<b>JRPP No</b>	<b>2011SYW044</b>
<b>DA Number</b>	<b>DA0110/11</b>
<b>Local Government Area</b>	<b>Ku-ring-gai Council</b>
<b>Proposed Development</b>	<b>Demolition of existing dwellings and construction of two residential flat buildings comprising 43 units, landscaping and associated works.</b>
<b>Street Address</b>	<b>6A &amp; 8 Buckingham Road Killara</b>
<b>Applicant/Owner</b>	<b>Aleksandar Design Group Pty Ltd</b>
<b>Number of Submissions</b>	<b>10</b>
<b>Recommendation</b>	<b>Refusal</b>
<b>Report by</b>	<b>Jonathan Goodwill, Executive Assessment Officer</b>

## SUMMARY SHEET

<b>REPORT TITLE:</b>	6A & 8 Buckingham Road, Killara
<b>LOT &amp; DP:</b>	Lot 3 & 4 DP 414101 (6A Buckingham Road) Lot 1 DP 414101 (8 Buckingham Road)
<b>PROPOSAL:</b>	Demolition of existing dwellings and construction of two residential flat buildings comprising 43 units, landscaping and associated works.
<b>DEVELOPMENT APPLICATION:</b>	DA0110/11
<b>WARD:</b>	Gordon
<b>APPLICANT:</b>	Aleksandar Design Group Pty Ltd
<b>OWNER:</b>	<ul style="list-style-type: none"><li>- 6A Buckingham Road: Mrs C A M Grundy</li><li>- 8 Buckingham Road: Mr J T L Gilroy and Mrs F M Gilroy</li></ul>
<b>DATE LODGED:</b>	10 Mar

**Figure 1 - when measured from the finished ground level of the courtyard of apartment 4 the wall plane has an area of 174m<sup>2</sup> before stepping back at the top floor level. This wall plane includes the open terrace on Level 2 and three balconies on Levels 3-5.**

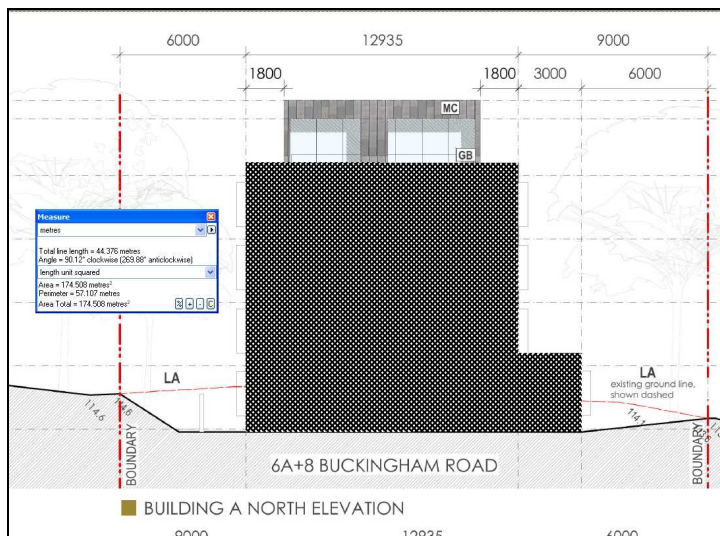
All facades to the public domain are required to be articulated with wall planes

varying in depth by not less than 600mm. Wall planes are not permitted to exceed an area of 81m<sup>2</sup>. Various methods of calculating the maximum wall plane area of the front elevation are illustrated on the diagrams below:

The variation to the wall plane depth and wall plane area controls is unacceptable because the development fails to achieve a visual connection between the dwellings and the public domain and the elements of the articulation do not have a strong relationship to the characteristics of existing buildings in the area. The primary concern is that the development fails to include a pedestrian entry that is visible from the street. The development could be improved by incorporating a pedestrian entry into the centre of Level 3. This option would avoid the need for a stair ascender at the side of the building and an access ramp could be centrally located in the front setback area. This option would give the development a clear identity and street address whilst improving safety through minimising entrapment and concealment spaces.
